# Access Compliance Report

## Public Rights-of-Way

### (Curb Ramps)

| Intersection ID: 29658                  | Main Street: PEVERELL_LN | Cross Street: TILESTON_CT               | Location:              | E                  |

| ADA ID: 0F5DC090C1CB                    | Ramp Type: Perp          | Initial Pass/Fail: Fail                 | Overall Compliance: No | Severity Score: 60 |

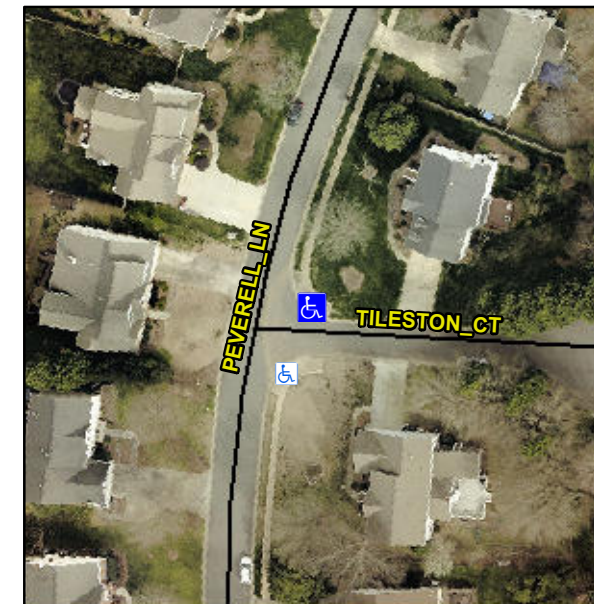
**Not Found, R304.5.1, R304.5.3**

| Compliance | Description           | Data  | Compliance | Description                 | Data |
|------------|-----------------------|-------|------------|-----------------------------|------|
| No         | Ramp Width (in)       | 30.5  | No         | Ramp XSlope (%)             | 10.4 |

**Remove & Replace Entire Ramp.**
